Product / Process Change Notification (PCN)

PCN #:	PCN_IndXHMI_20181023	Change Category:
Affected Series:	WE-XHMI-6030, 6060, 8080, 1090, 1510; 744393xxxxx	<input type="checkbox"/> Equipment / Location
PCN Date:	July 23, 2018	<input checked="" type="checkbox"/> General Data
Effective Date:	October 23, 2018	<input type="checkbox"/> Material
		<input type="checkbox"/> Process
		<input type="checkbox"/> Product Design
		<input type="checkbox"/> Shipping / Packaging
		<input type="checkbox"/> Supplier

Size	Before Change	After Change
6030, 6060		
8080		
1090

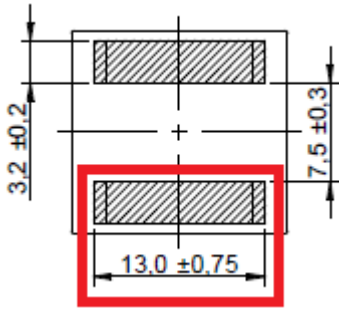
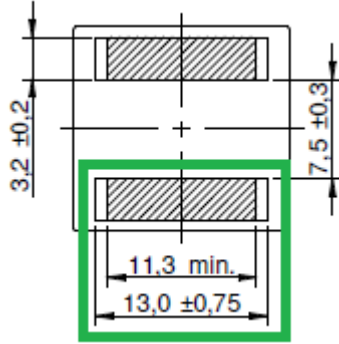
The following additional dimensions will be specified on the bottom view of the part:
